# Memorandum to the City of Markham Committee of Adjustment

**File:** A/026/23  
**Address:** 74 Beckenridge Drive, Markham  
**Applicant:** Steven Steiger  
**Agent:** Square Design Consulting (Anthony Bartolini)  
**Hearing Date:** Wednesday, May 17, 2023

The Applicant is requesting relief from the City-wide Deck By-law 142-95, as amended, as it relates to a proposed deck and covered porch in the rear yard. The variance requested is to permit:

**1 FLOOR PLAN**  
A2 1:50

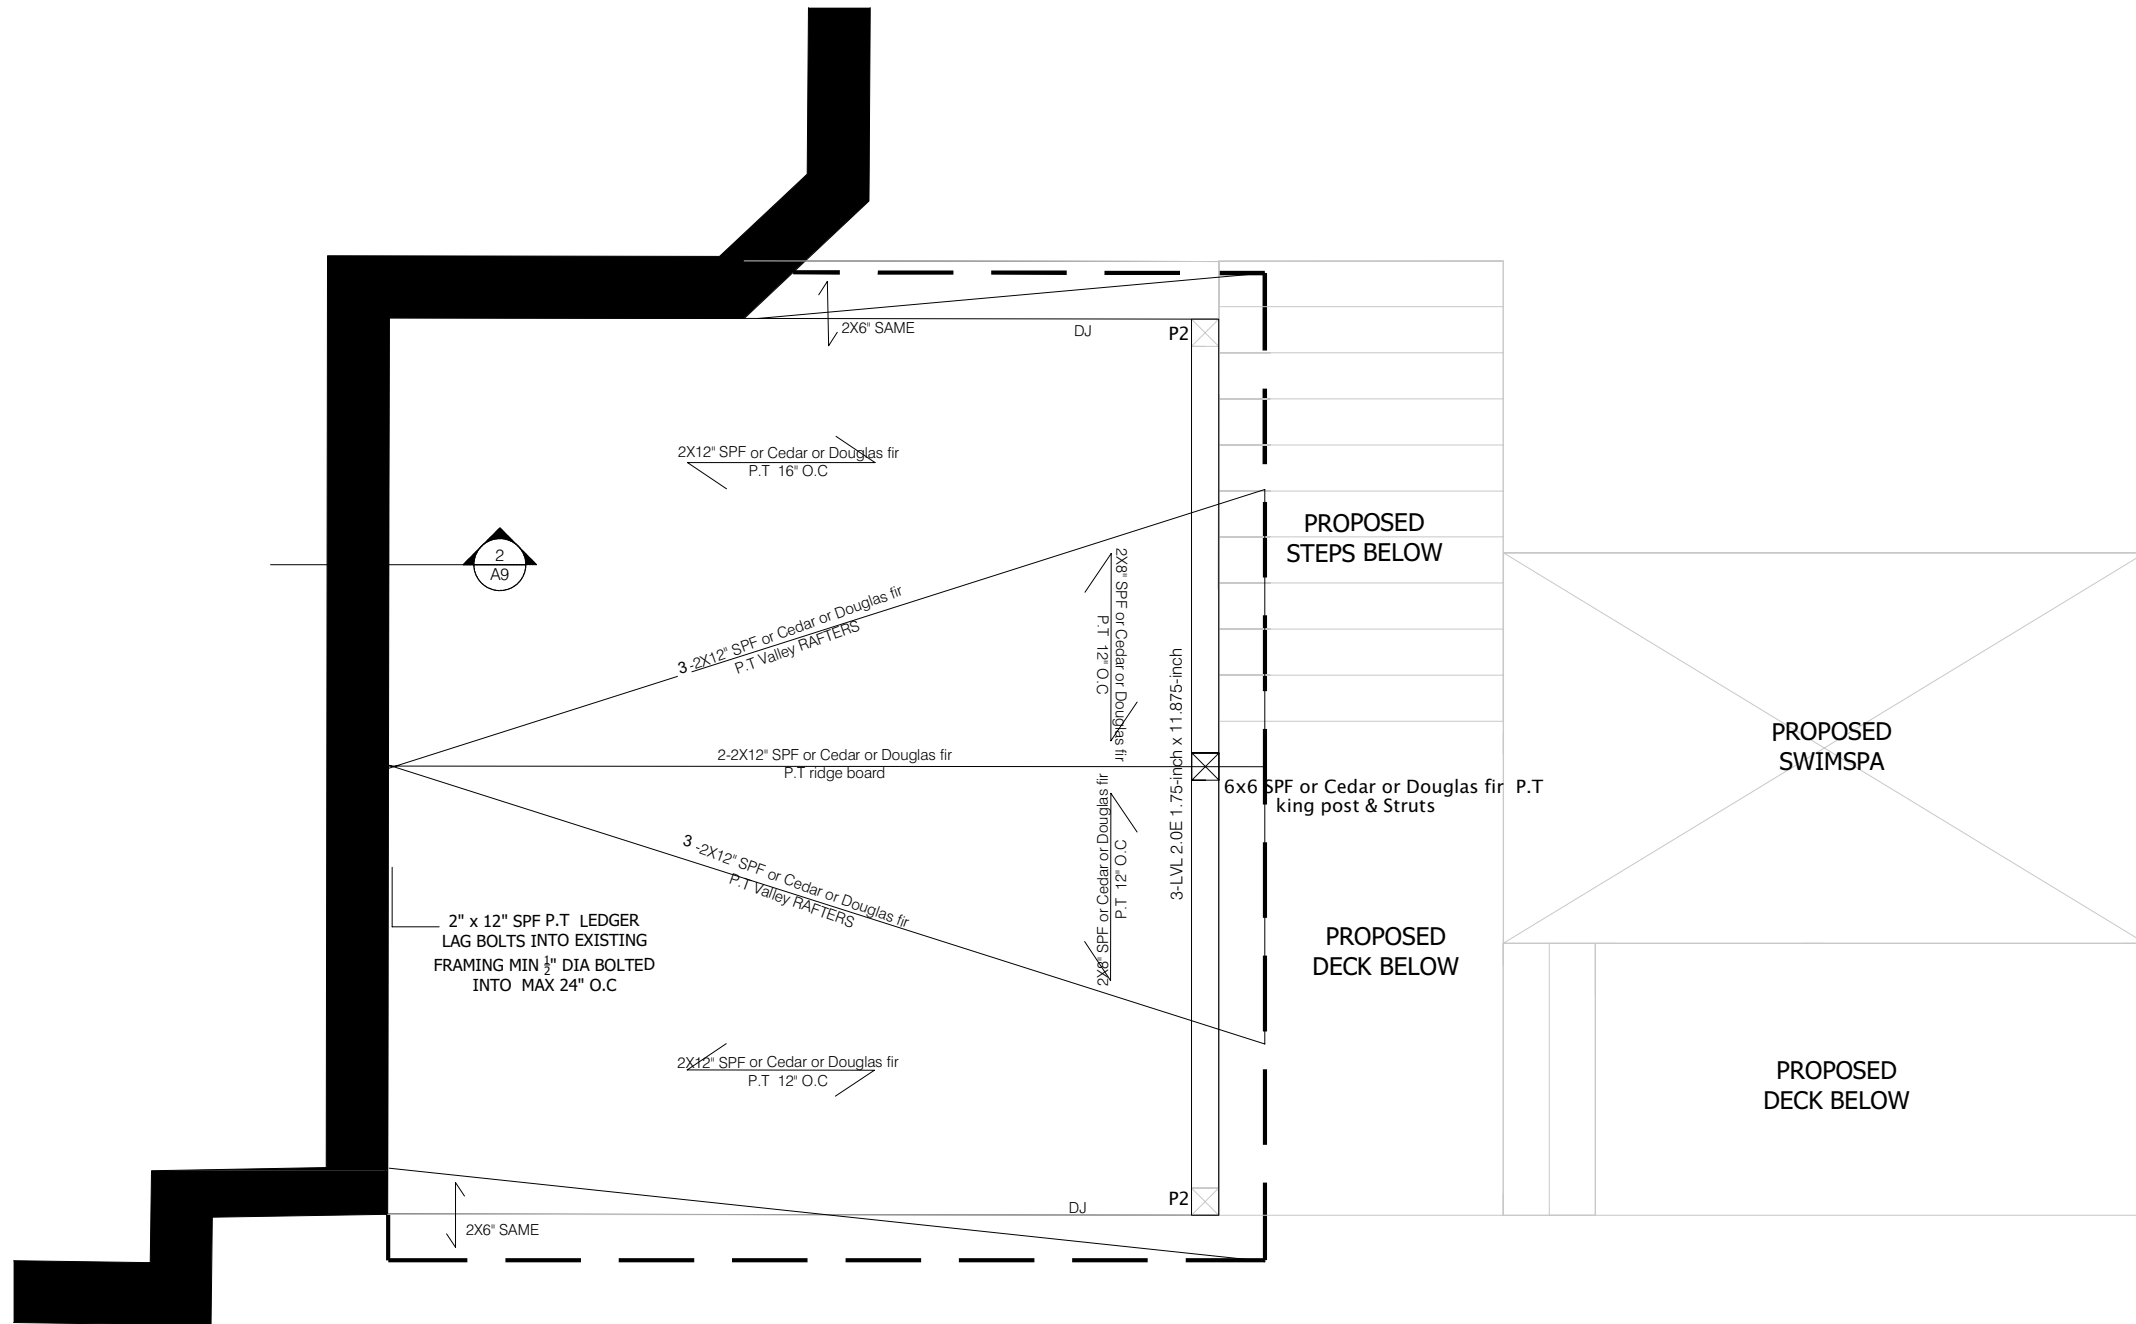
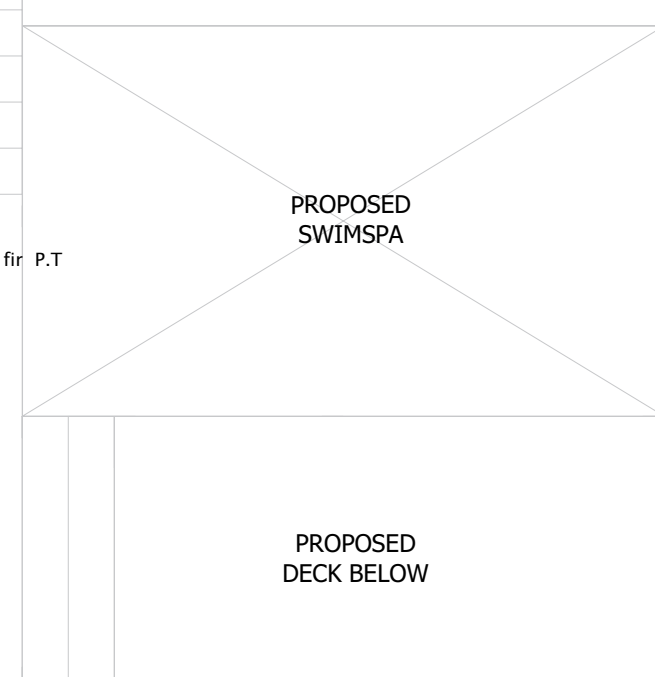
The Applicant is requesting a maximum deck projection of 8.26 metres (27.10 feet) from the point on the dwelling closest to the rear lot line, whereas the By-law permits a maximum deck projection of 3 metres (9.84 feet) from the point on the

dwelling closest to the rear lot line. This represents an increase of approximately 5.26 metres (17.26 feet).

The Applicant is not applying for variances for lot coverage, height, or setbacks. The proposed deck is accessed off the first storey of the dwelling; has a height of 0.699 metres (2.29 feet) above average grade; is partly covered; and, maintains a rear yard setback of 20.03 metres (65.71 feet). Given the lot size, Staff are of the opinion that the variance requested is minor in nature and have no concern with the requested variance.
